To: Auburn Planning Board
From: Megan Norwood, City Planner II
Re: North River Road (PID 271-101), Proposed 3, 12-Unit Apartment Buildings and associated parking, driveways, landscaping, utilities, & other site improvements in the General Business Zoning District.
Date: November 12, 2019

I. PROPOSAL – SurveyWorks, Inc. on behalf of Tim Millett is seeking **Preliminary** Subdivision approval pursuant to Chapter 60, Article XVI Division 4, Subdivision, Sec. 60-1359 of the Auburn Code of Ordinances. Final Subdivision review will be scheduled for the December meeting.

Figure 2: Subject Parcel (Shoreland Zone)

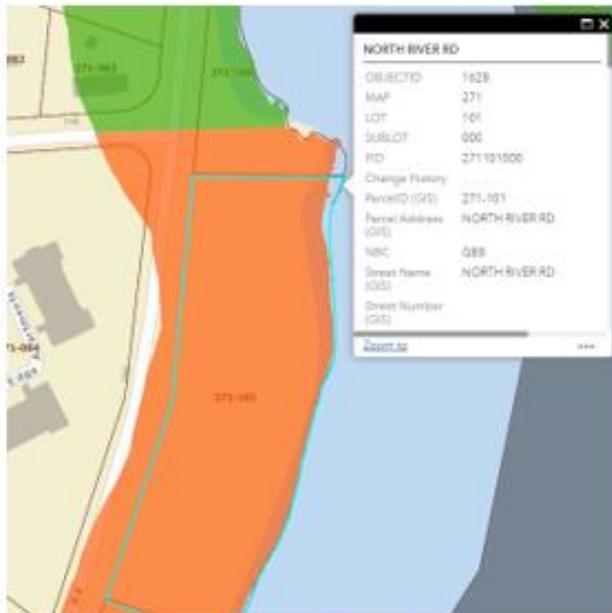
Sec. 60-992. – Principal and Accessory Structures. The orange area on the map to the left (Figure 2) is the General Development Shoreland Zone area.

- Per Subsection (a): General Development areas require a 25-foot setback from the normal high-water line. *The buildings are located outside of the 25-Foot setback from the normal high-water line. For clarification purposes, Planning Staff would recommend delineating the 25-foot setback and normal high-water line on the final plan.*
- Per Subsection (b): Principal structures cannot exceed 35 feet in height.
